CERTIFICATE OF APPROPRIATENESS

Property: 215 W 16th Street, lots 41, 42 & 43, block 132, Houston Heights Subdivision. The property includes a historic 1,222 square foot, one-story wood frame single-family residence and a detached shed situated on a 10,200 square foot (75' x 136') interior lot.

Proposal: Alteration – The applicant received partial approval in January 2015 to construct a 3,200 square foot two story addition and attached garage at the rear wall of the contributing one story residence.

Recommendation: **Partial Approval: Approval to remove aluminum window on the west wall and replace with a larger wood window in the same location. Denial to move window opening and install two new window openings**

WEST SIDE ELEVATION

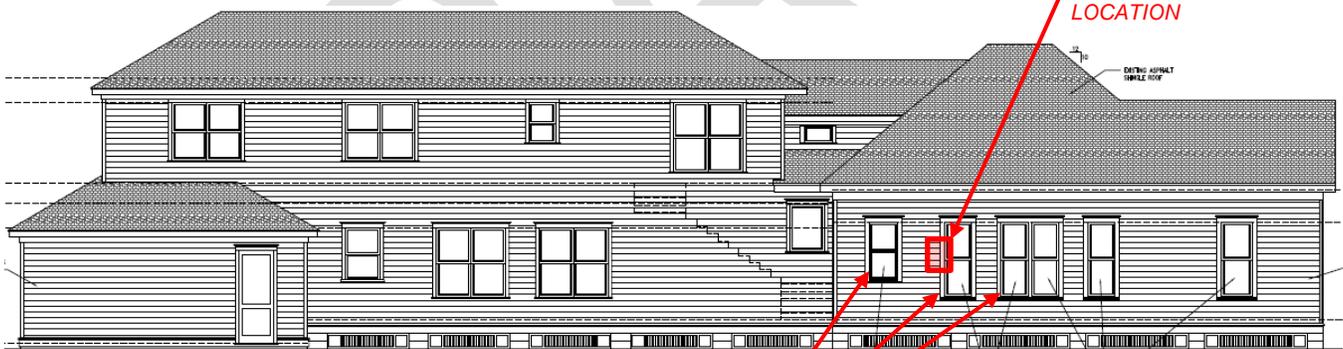
<i>The existing rhythm of solid to void created by window openings on the west wall would be disrupted by the proposed changes to opening locations. The creation of a paired set of windows has no precedent on the existing house.</i> |

<i>The window pattern on the west wall is distinct to this house and is consistent with the house's other walls. Disrupting that pattern and creating a paired set of windows permanently alters this pattern.</i> |

<i>The installation of two new window openings and relocation of one existing window opening on the west wall destroys significant historic siding and wall material.</i> |
